Delegated officer report for planning application

Application no. 140191/FO/2024

Proposal: Installation of 1no. Air Handling Unit to external space adjacent to the existing Endoscopy Department and new fence line to enclose the plant installation

Address: North Manchester General Hospital, Delaunays Road, Manchester, M8 5RB

Figure 1, Material chosen for new fence line

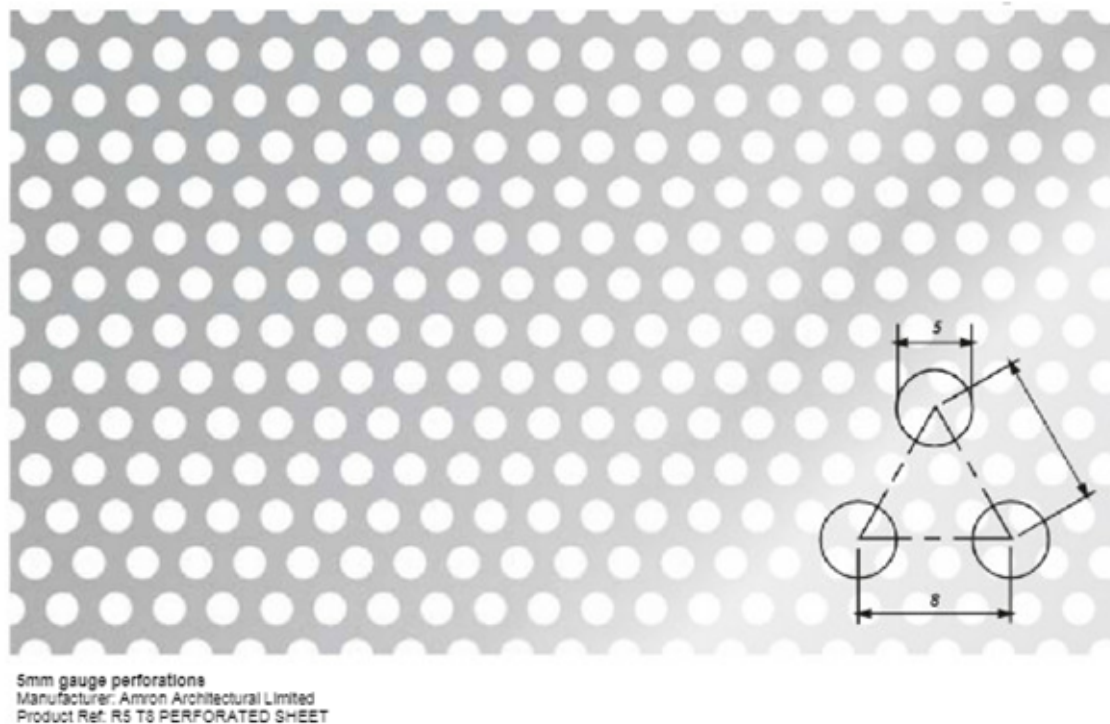
Clarification was also sought in regard to the boundary treatment specification/ material to be used for the proposal.

There will be a proposed 3.0m high screening with 5mm gauge perforations around the perimeter of the AHU. This is deemed acceptable to Highways.

Furthermore, the boundary treatment chosen for the unit is considered to be a suitable design and quality, so not to create an unduly harmful feature in the streetscene. The proposed materials to be used would closely match the existing screening to the north of the applicant site (see planning reference: 131018/FO/2021), and so shows a level of continuity in development appearance within the immediate context. The perforated screening would take the form of a 5mm gauge perforations and the manufacturer would be an Amron Architectural Limited, product ref: R5 T8 Perforated Sheet, in a grey colouration. Via email, the agent explained the 5mm option has been chosen to ensure health and safety, to ensure people do not trap fingers or insert anything into the perforations. As such, consideration has been given to the appearance of the proposal. Given this, the proposal is designed in a way to reduce visual harm, as much as is possible given the utilitarian feel of the development. A condition ensuring the scheme is implemented in accordance with the proposed materials would be attached to any approval granted, and a further condition relating to the proposed fence link at the site.

3) The materials to be used throughout the proposal hereby permitted shall be implemented in accordance with the approved details as set out in the Application Form and 'Drawing- Proposed- External Fencing Details, numbered P3' specified in Condition 2 of this approval.
